Watts Bar Nuclear Plant, Unit 2
NRC Docket No. 50-391

Subject: Watts Bar Nuclear Plant (WBN) Unit 2 – Response to Request for Additional Information (RAI) Regarding June 28, 2011 NRC Audit – Steam Line Break (SLB) and other Miscellaneous RAIs

Enclosure 3
TVA Letter Dated July 29, 2011
FSAR mark-ups for SLB transients

Figure 15.4-11c Transient Response to Steam Line Break with Safety Injection and Offsite Power (CASE A)

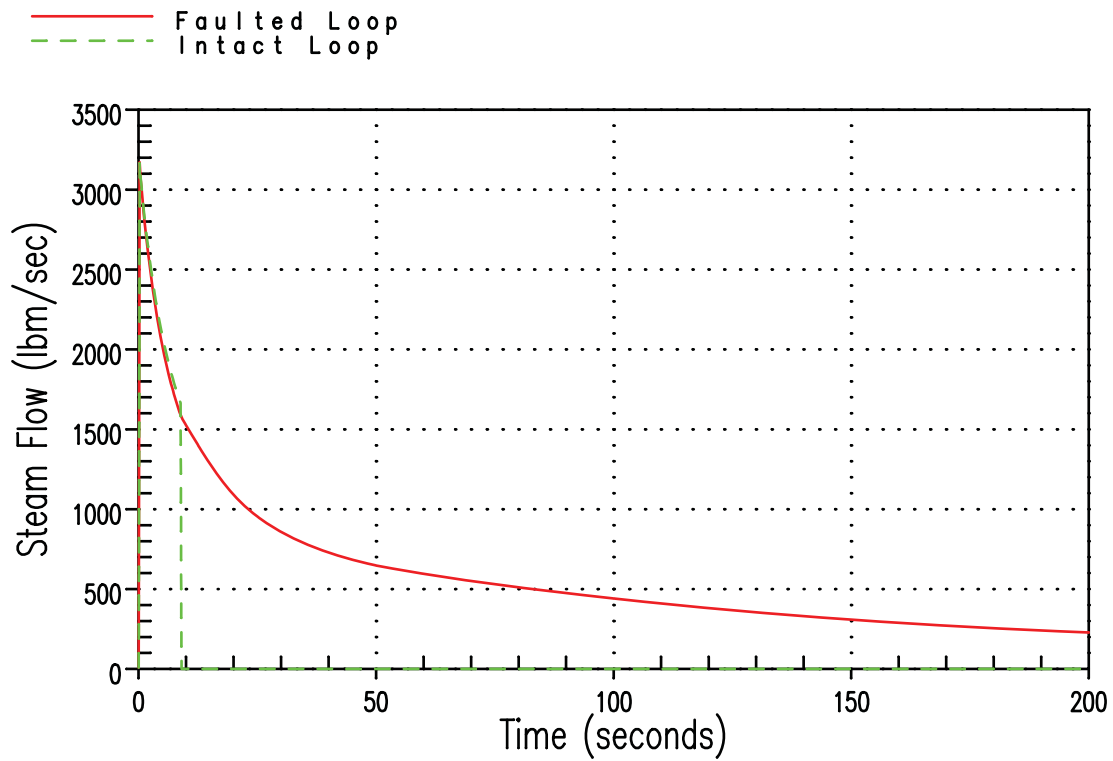
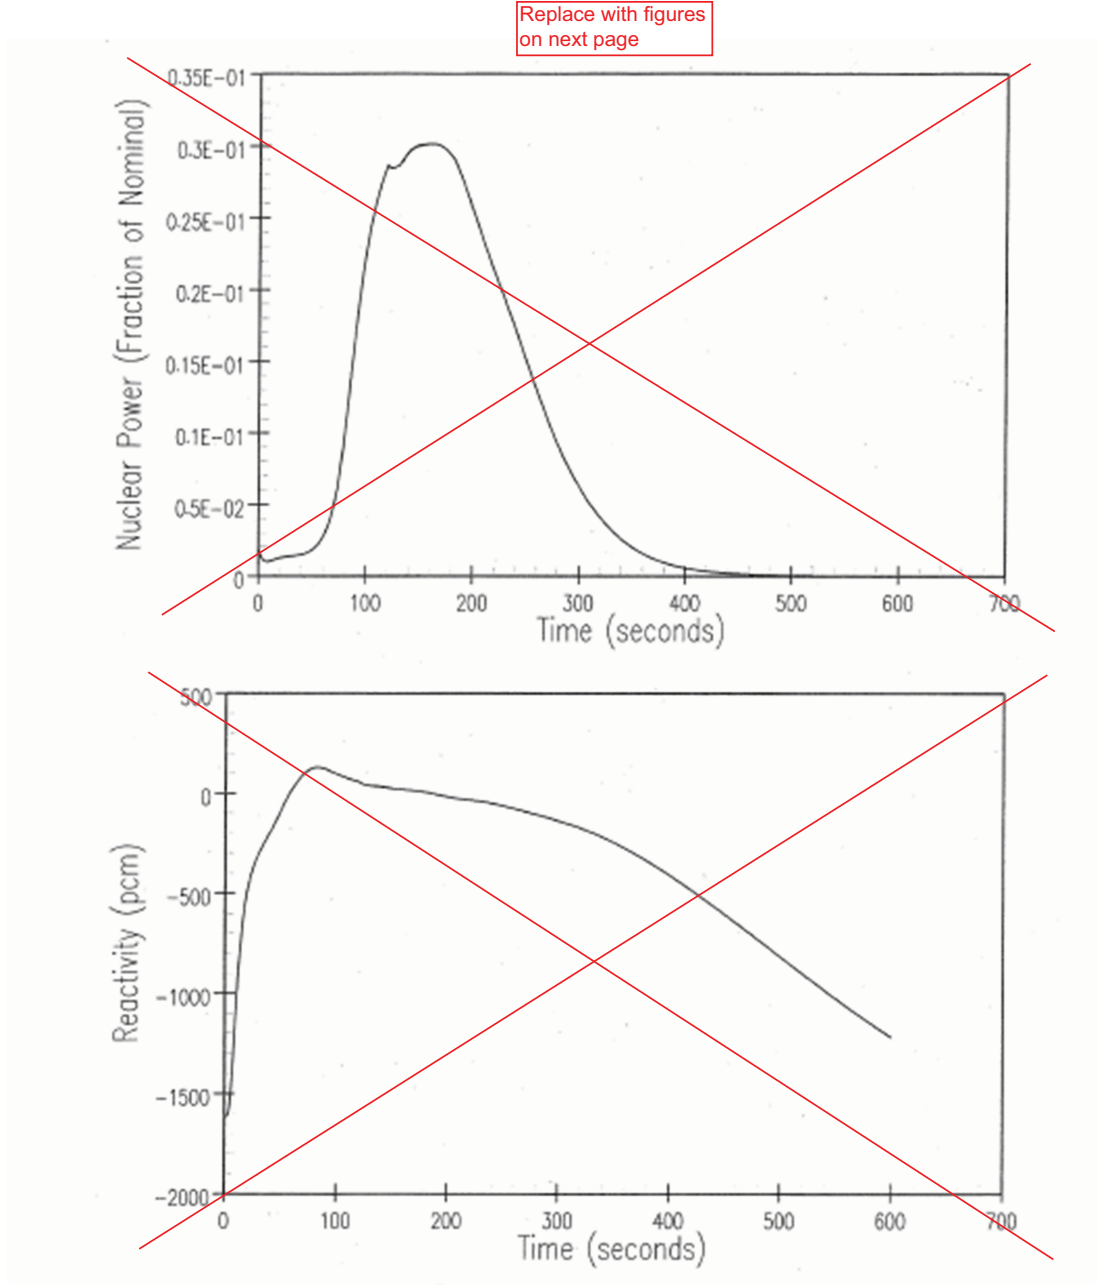
Replace with figure
on next page

Figure 15.4-12a Transient Response to Steam Line Break without Offsite Power
Nuclear Power and Reactivity Versus Time

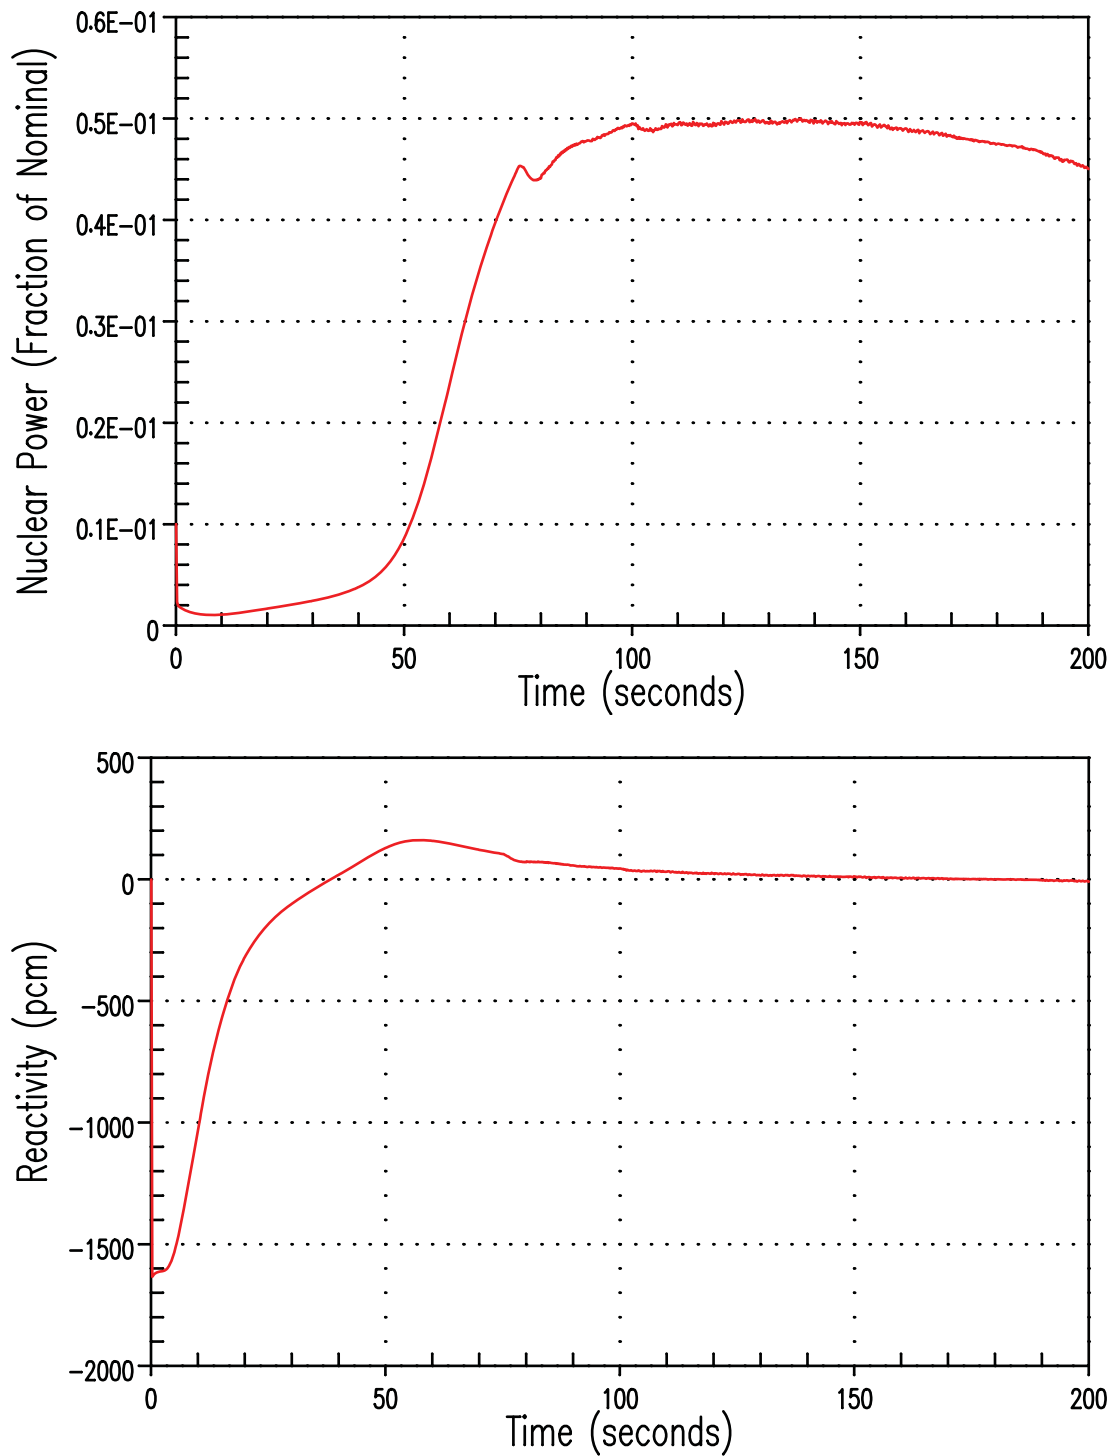
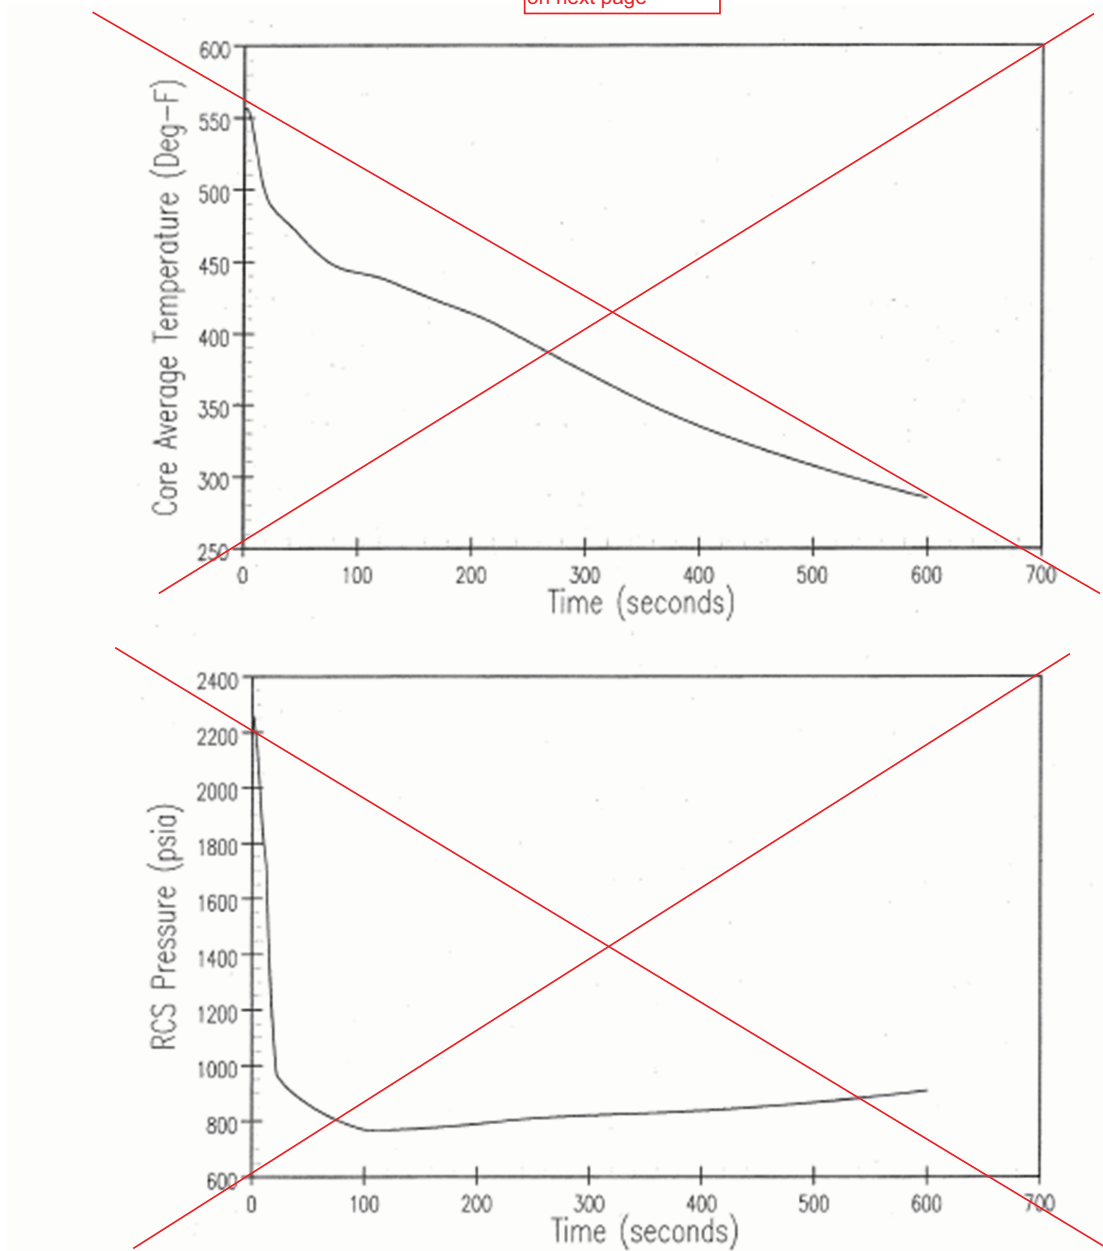
Replace with figures
on next page

Figures 15.4-12a through 15.4-12c show the responses of the salient parameters for Case b which corresponds to the case discussed above with additional loss of offsite power at the time the safety injection signal is generated. The injection of borated water is conservatively delayed to 37 seconds based on the assumed 10 second diesel generator delay time plus the 27 seconds associated with the valve lineup for the offsite power available case (Case a). In this case criticality is achieved later and the core power increase is slower than in the similar case with offsite power available. The ability of the emptying steam generator to extract heat from the reactor coolant system is reduced by the decreased flow in the reactor coolant system. For both these cases the peak power remains well below the nominal full power value.
